SUMA NUCLEAR
PHARMACY

GRADING & DRAINAGE PLAN

ENERPHARM HEADQUARTERS BLDG
BALLOON PARK ROAD AND KIRCHER BLVD
ALBUQUERQUE, NEW MEXICO

DRAINAGE / GRADING PLAN
SUMA NUCLEAR PHARMACY
4272 BALLOON FIELD ROAD

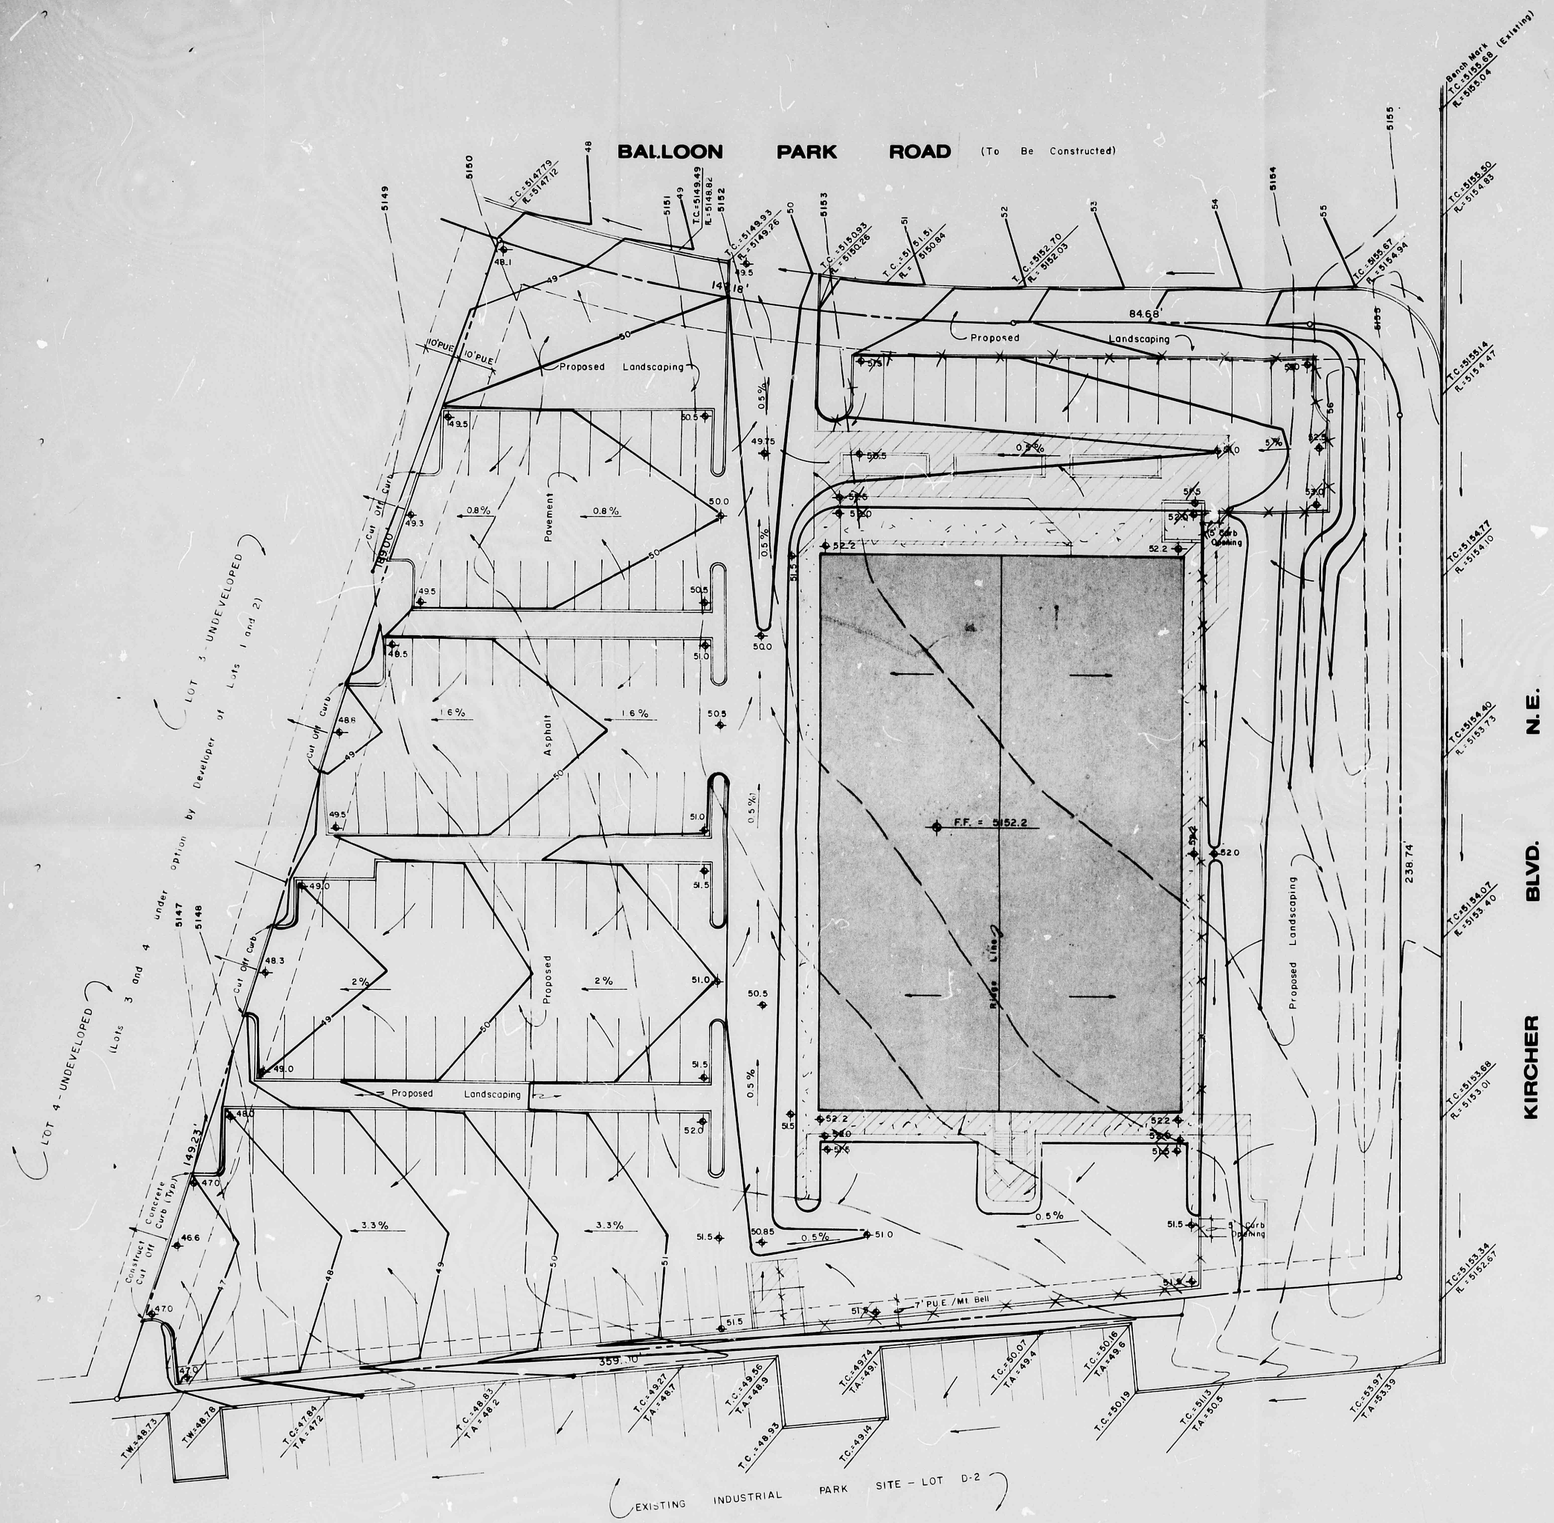
ITEMS MARKED OUT (X) HAVE BEEN DELETED FROM ORIGINAL PLAN.

INDICATES ADDITIONS TO ORIGINAL PLAN

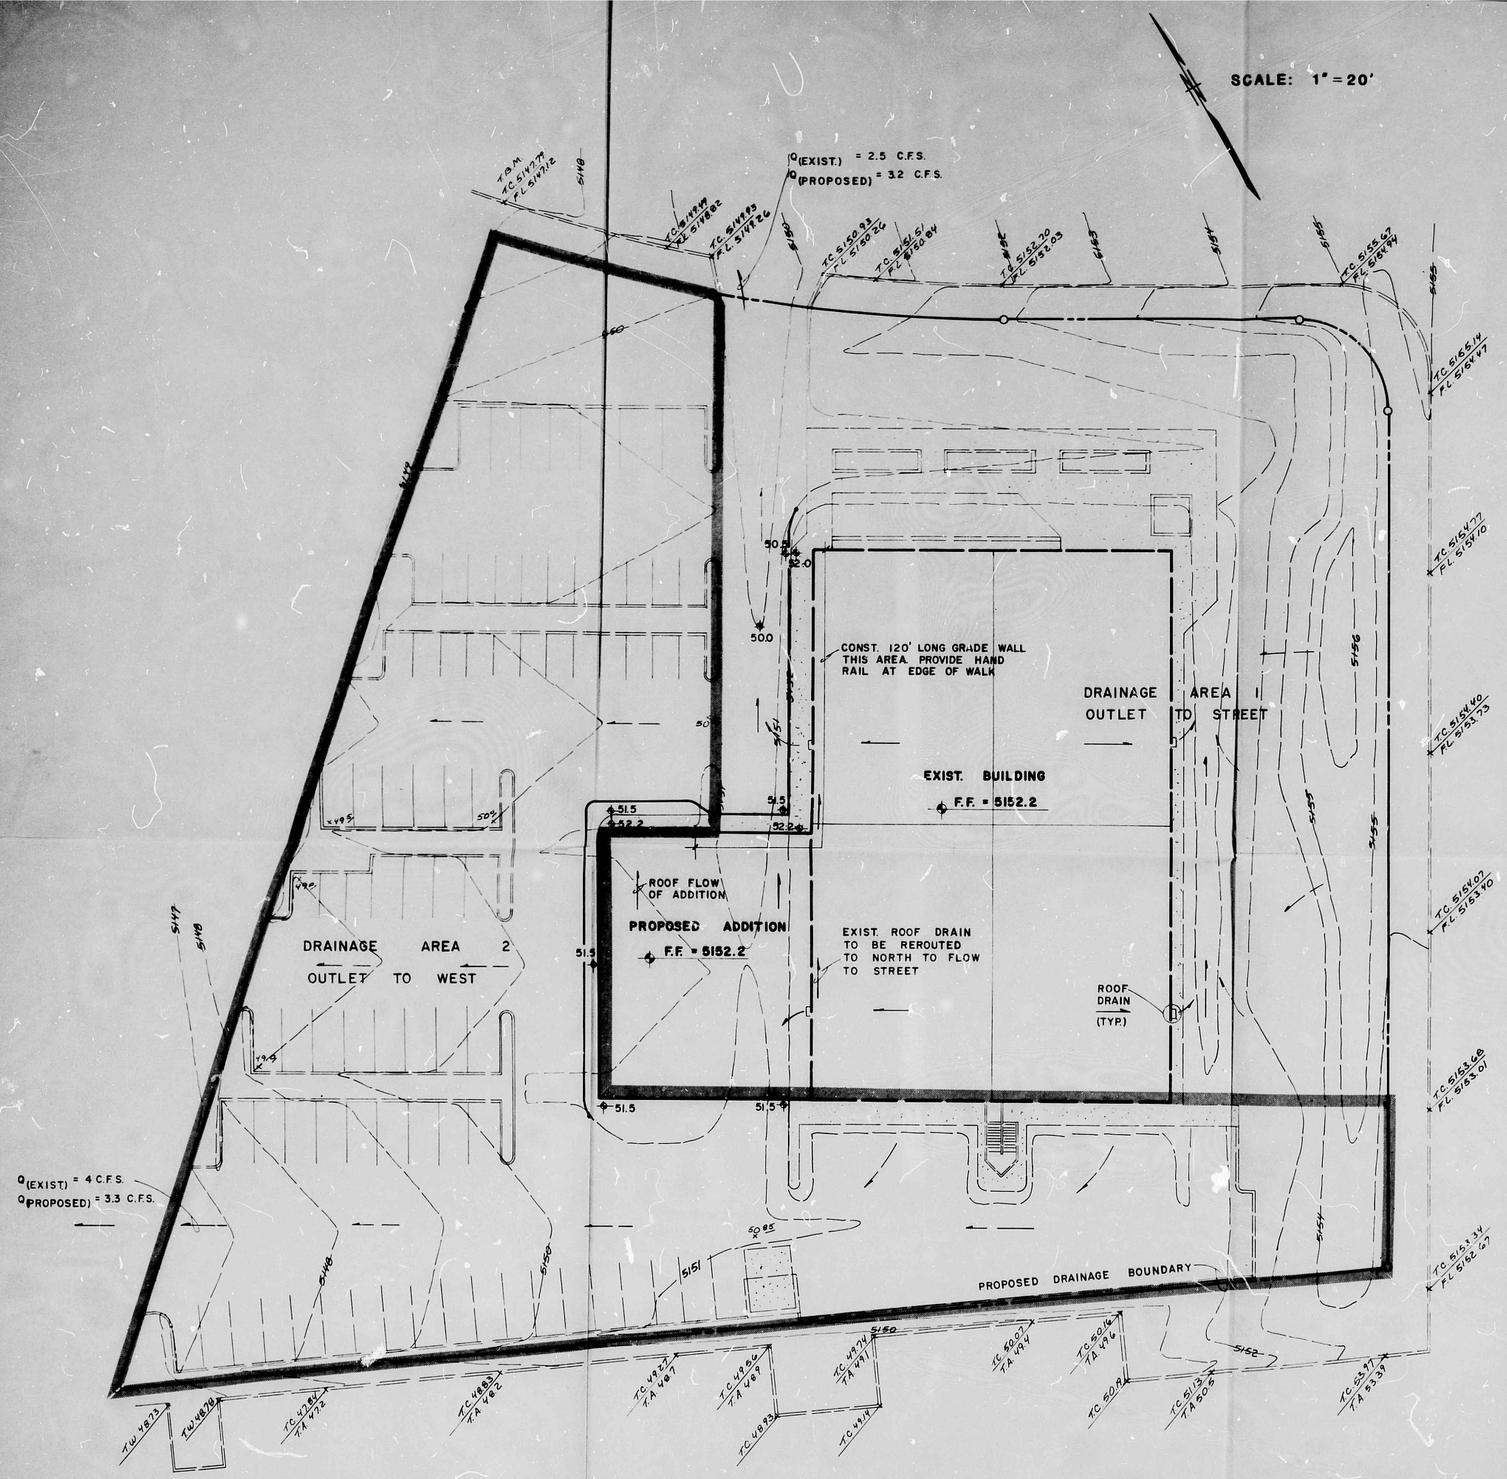
RESUBMITTAL 11-1-85:
REVISED FLOW PATTERNS TO REFLECT INCORRECT EXISTING GRADES SOUTH SIDE OF PROPOSED ADDITION.
